64-F-246M  
THESSALON RIVER  
AT LITTLE RAPIDS  
MacDONALD BRIDGE  
LOTS 17+19  
RIVER RANGE

Township of Thessalon,  
MacDonald's Bridge over the Thessalon River,  
Lots 17 and 19, River Range,  
District of Algoma,  
Structure Site No. 38-195 - Your File No. BA 1872

# SOILS INVESTIGATION FOR PROPOSED MACDONALD

Township of Thessalon,  
Bridge over the Thessalon River,  
Lots 17 & 19 (MacDonalds Bridge)  
Structure Site No. 504-195  
Your File No. B4 1872

<b>M. R. WRIGHT &amp; ASSOCIATES</b>	
			CONSULTING ENGINEERS	
			SAULT STE. MARIE	ONTARIO
DRAWN	J	PROJECT - PROPOSED MacDONALD BRIDGE		
CHECKED	W	OVER THE THESSALON RIVER AT		
APPROVED		THESSALON ONT		
DATE	June 1994	DETAIL		
SCALE	As Noted	OWNER	TOWNSHIP OF THESSALON	
PROJECT NO.	1033	DWG. NO.	ONE

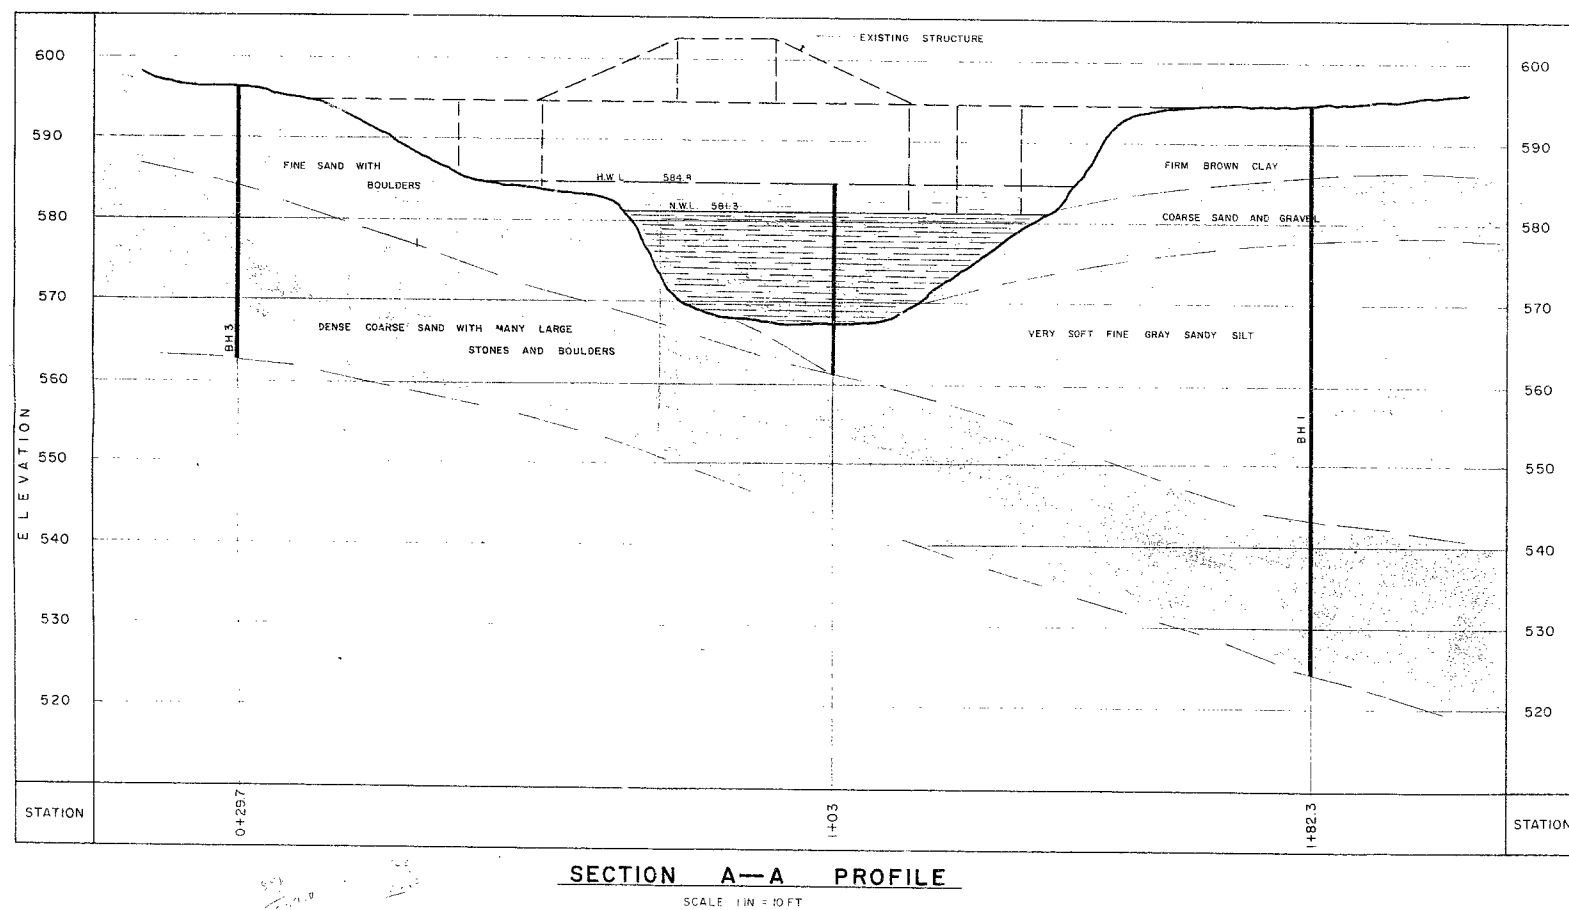
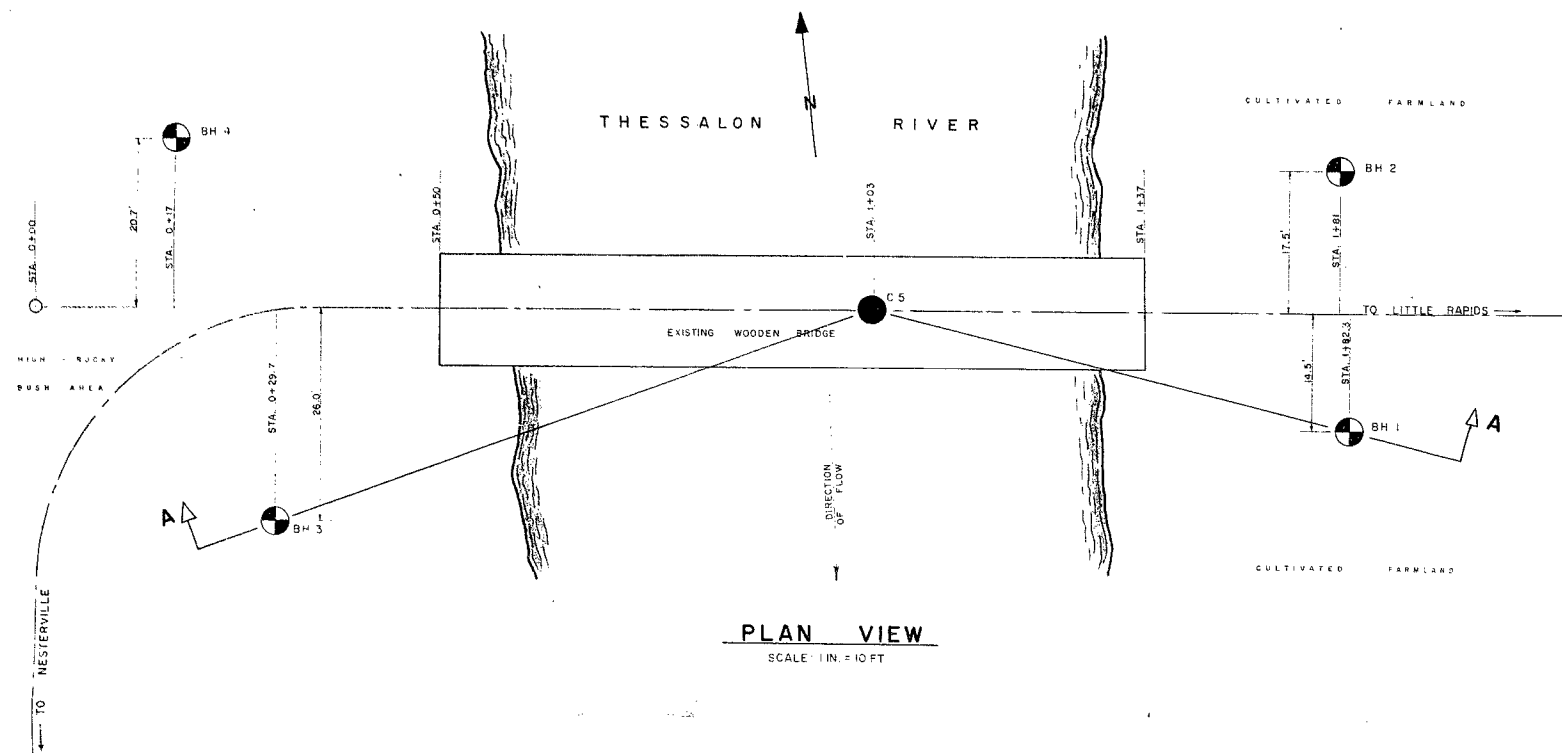
Steel H-piles as supports for both the East and West abutments, are recommended by the Consultant. At the West abutment the proposed footing elevation is 579.0 and the piles are supposed to be driven to El. 563.0 where refusal should be met.

In our opinion, it is very doubtful whether piles can be driven that far. In the course of the investigation, it was impossible to advance casing and drive the Standard Penetration Sampler beyond El. 579.0, and drilling had to be resorted to. The material of the banks is scour susceptible and footings that would derive their bearing from the layer lying below the present river bottom (approx. El. 568.0) are desirable. However, due to the above-mentioned, this may prove to be either impossible or very difficult to achieve.

At the East abutment, the pile tip elevation - i.e., the elevation where refusal is to be met, is given as 540.0. Here, however, the reported conditions are such (penetration in B.H. 2 possible without drilling) that piles may not meet refusal and could penetrate much farther.

The estimated cost of \$47,239.00 for the proposed bridge at this site is, of course, based on the described foundation alternative. However, in view of the comments in connection with the possible early pile refusal on the West bank and the possible deeper pile penetration on the East bank, the cost of foundations may differ quite significantly from the assumed one.

The proposed alternative for footings to be founded on steel H-piles driven into the dense sand stratum with gravel and boulders, seems to be the best solution. Because of the presence of seemingly large boulders, it is practically impossible to predict how far the piles will penetrate into this layer. We would suggest that the bearing capacity of the piles be checked by the Wiley Formula in case refusal is not met, by hitting a boulder.
